FEBRUARY 2015 PUBLIC COMMENT SUMMARY SR 520 WEST SIDE FINAL CONCEPT DESIGN REPORT

Final Concept Design (20-foot-wide passageway). Passages have been designed to provide mode separation and clear lines of sight for users.

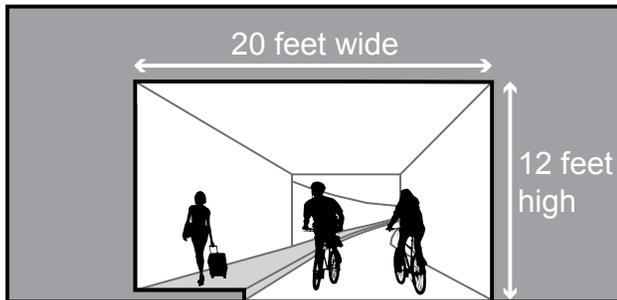
- People would like the path to be wide enough to allow for the separation of bicycles and pedestrians. Grade separation by mode was also frequently suggested.

Response: All shared-use paths within the WSDOT project corridor will be a minimum of 14 feet wide to allow for safe use by pedestrians and bicyclists. At undercrossings, paths are 20 feet wide, providing clear separation for users through the use of distinctive surface treatments, including a 6-foot wide concrete pedestrian sidewalk and a 14-foot wide asphalt cycle way. For more detailed information, see the [SR 520 West Side Final Concept Design Report \(pages 50 - 52\)](#), including [Appendix B Non-motorized Connectivity Technical White Paper \(page 118\)](#).

A diagrammatic description of the facility functions.

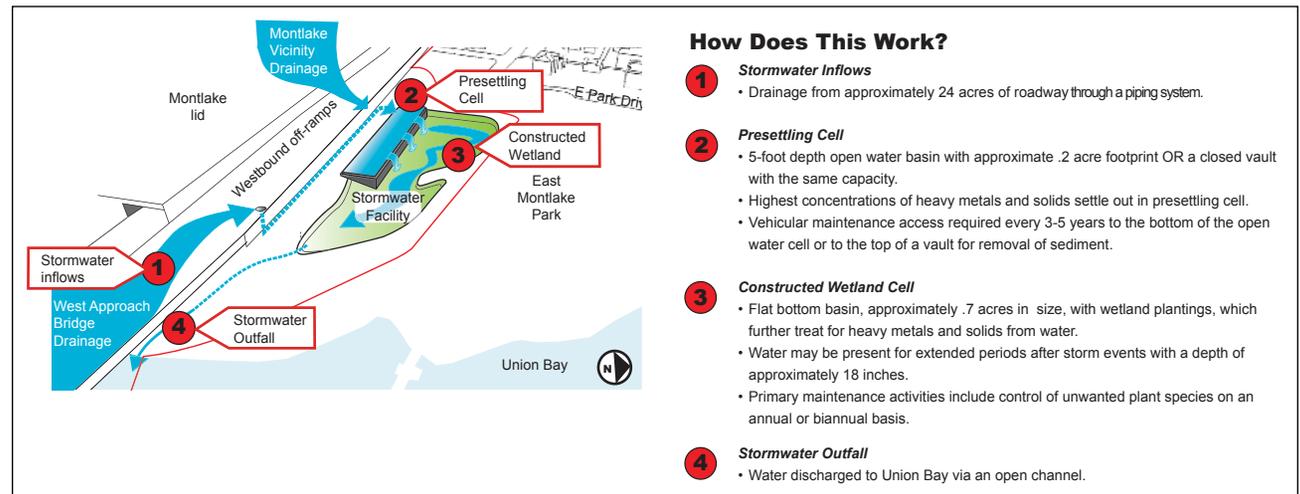
concept shows a long distance between the shoreline and the designated parking areas, which can be difficult for people to haul boats.

◇ **Response:** WSDOT coordinated with Seattle Parks to design access for the hand-carry boat launch. The resulting design sought to minimize impacts to open space by eliminating large-scale parking areas while maintaining an ADA-accessible path from the parking area to the boat launch area. Kayak users can use hand-pulled trailers along the approximately 500-foot-long path. Continued design refinements will be made to ensure access for all users.

Map of Needed Improvements

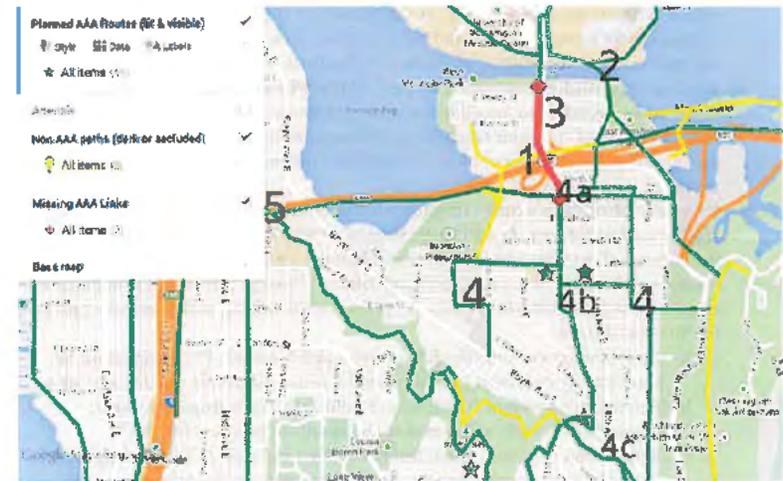
1. **Create a direct and comfortable walking and bicycling connection from the Central Greenway to UW Medical Center on the West side of Montlake Blvd.** This connection is in the existing Bicycle Master Plan. Now is the opportunity to build this important connection. This connection must also be appropriate for a 12 year old girl to access the Husky Stadium Light Rail station.

2. **Improve walking and biking access across the Montlake Cut.** WSDOT dropped plans to fund improved access for people walking and biking in the latest round. A report commissioned by the city found that the Montlake Bridge is inadequate for current walking and biking use, let alone future growth after the light rail station opens. A walking and biking only bridge is the best solution.

4. **Preserve Montlake's quiet neighborhood character from new cut through traffic and provide safe routes to school.** WSDOT must provide funding to finish the network of neighborhood greenways in Montlake which will protect the quiet residential character of the neighborhood from cut through traffic, and simultaneously create safe and comfortable ways for people to walk to school, parks, transit stops, and the business district.

5. **Create family friendly access to the 520 trail.** In the current designs, the 520 trail ends at Delmar Dr E after it crosses the Portage Bay Bridge. The trail must be connected seamlessly to the Federal Ave E and 10th Ave E in a way that is comfortable for families on foot or bicycles. In addition, a protected bike lane along part of Delmar Dr E & E Roanoke St should be built to create a family friendly connection at street level between the Portage Bay Bridge Trail and the Capitol Hill and Eastlake Neighborhoods.

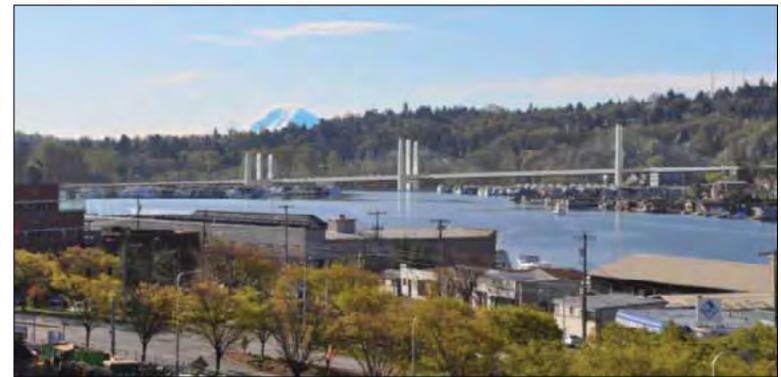
WSDOT presented the SDC with three separate versions of a cable stay bridge over Portage Bay. Our initial review began with the two-tower version evaluated in the Final Environmental Impact Statement (FEIS). During our review, WSDOT refined the cable stay concept to include two additional bridge types—one with a single tall tower and the other with three towers of various heights. In all versions, the eastern portion of the bridge nearest Montlake is a beam bridge; this secondary bridge type reduces construction costs. Attachment A shows the cable stay designs we considered.

Cable stay bridges offer the opportunity to reduce the amount of structure below the bridge deck. Spans can be wider, columns fewer, and the bridge deck thinner. These characteristics create a positive environment for portions of Portage Bay used for recreation purposes at or near the water and improve the overall experiential quality of the bridge. The distinctive character of cable stay bridges and their vertical elements attracts the eye and commands attention. When properly designed and sited, these elements can enhance and define their settings. However, the concept alternatives the SDC reviewed overpowered Portage Bay and its unique context. The visual impacts of these vertical elements detracted from the desirable horizontal character and lightness inherent in cable stay bridges.
